Addendum 122 – Regulation No. 123

Revision 1 - Amendment 4

Supplement 4 to the 01 series of amendments – Date of entry into force: 15 July 2013

Uniform provisions concerning the approval of adaptive front-lighting systems (AFS) for motor vehicles

Examples of arrangements of approval marks

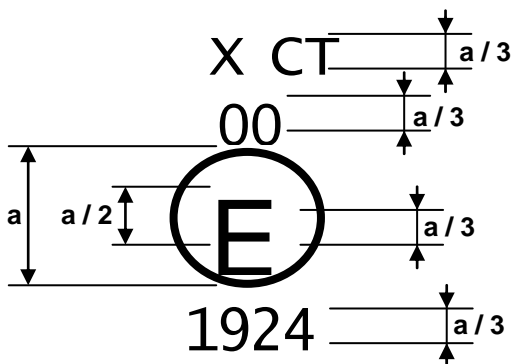
Annex 2, amend to read:

<p>$a \geq 8$ mm (on glass) $a \geq 5$ mm (on plastic material)</p>
